Secondary Air Injection System - Water Intrusion: MIL "ON" DTC P0418, P0419, and/or P244#

SUPERSESSION NOTICE

The information contained in this bulletin supersedes SB Nos. T-SB-0329-08 and T-SB-0350-09.

- Applicability has been updated to include 2009 – 2011 model year Sequoia and Tundra vehicles.
- The air pump inlet has been updated to prevent water intrusion.

Figure 1.

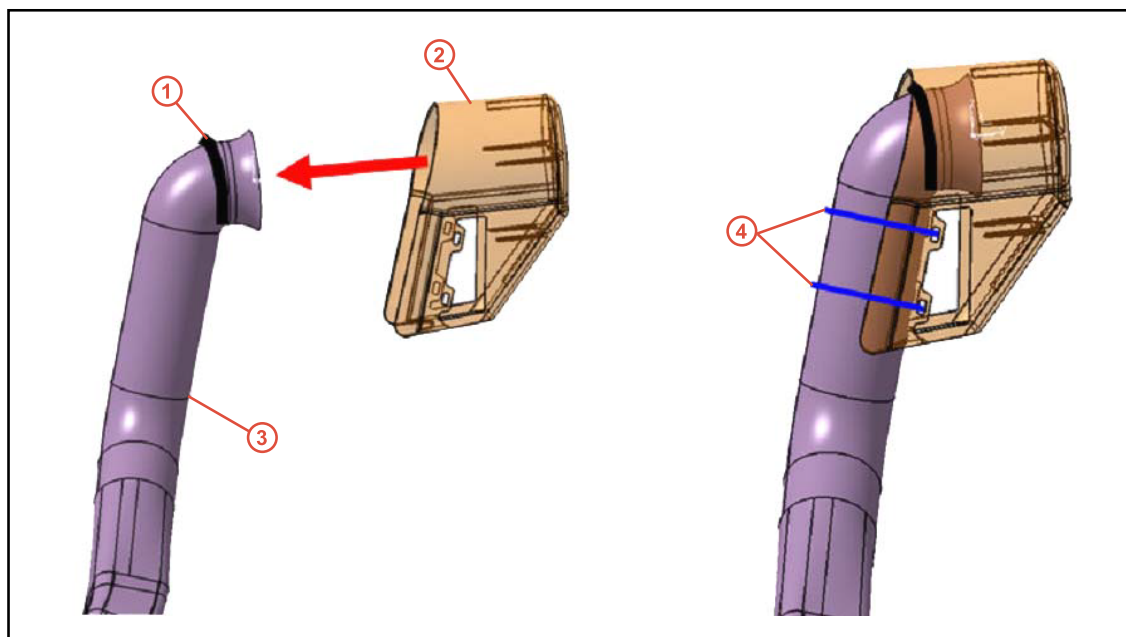
- **ONLY** replace the Bank 2 pump.
- Install the foam seal to the top of the air inlet along the inlet's edge and then attach the cover with zip ties as shown below. The zip tie length should be a minimum of 2.5 in. (64 mm) in length when tightened.

Figure 2. 1GR-FE/3UR-FE/1UR-FE Air Injection Pump Assembly (with clamps)

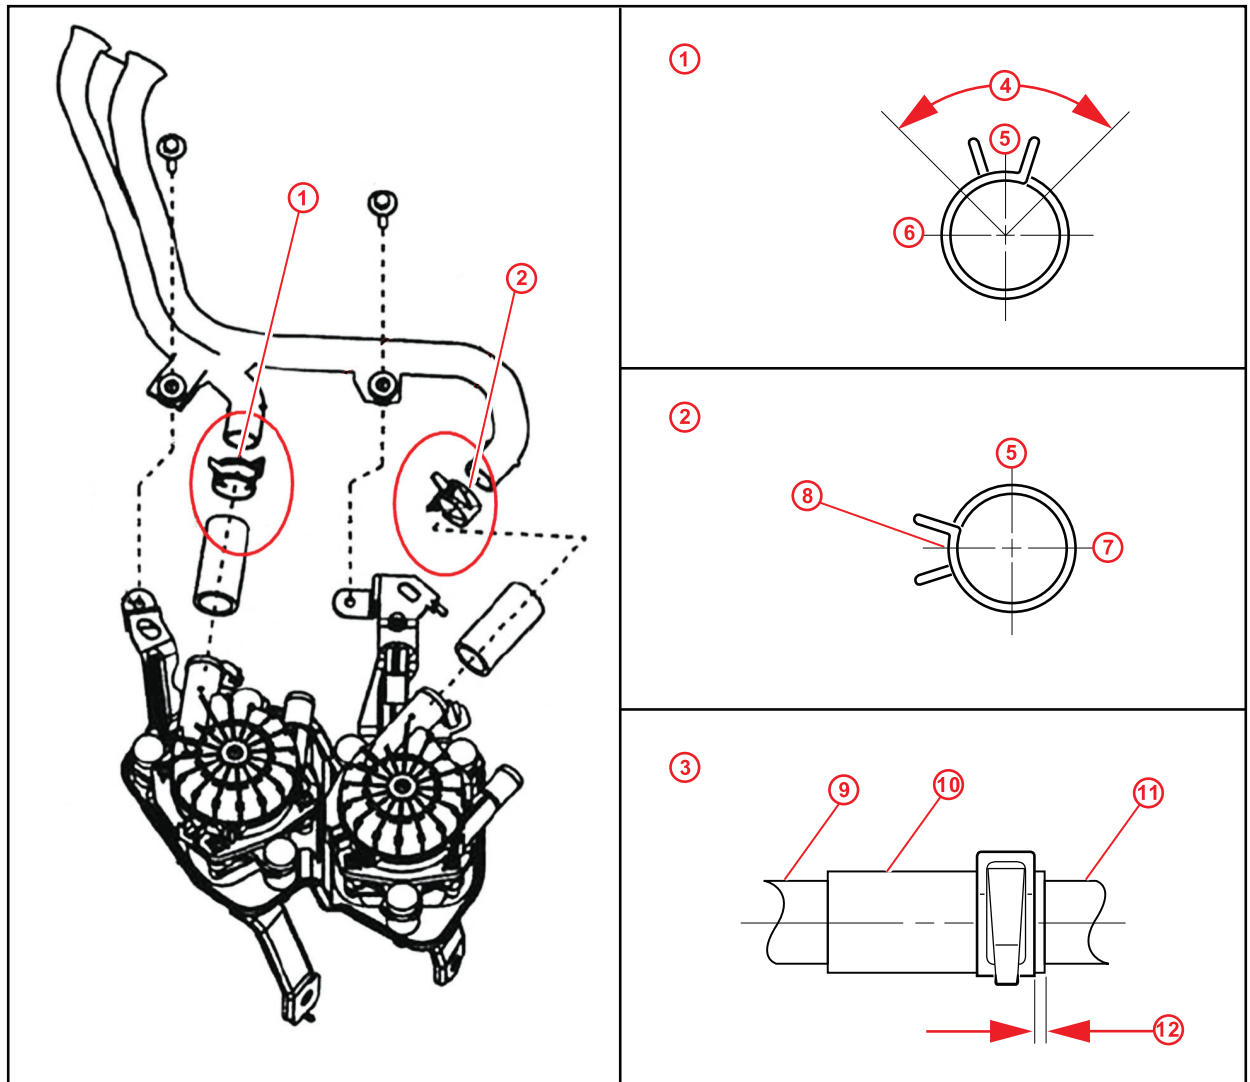
5. If liquid evidence is present, follow the steps below.
 - A. Replace the air pump inlet.
 - B. Install the inlet cover (2UZ-FE only).
 - C. Replace all air pumps under the fender well.
 - D. Install clamps on the inlet pipe to air pump hose joint where not currently installed, as shown in Figures 2 and 3.

Make sure the clamp orientation is as shown in Figures 2 and 3.

ONLY install clamps on vehicles where they are not currently installed. If already present, reuse the currently installed clamps.
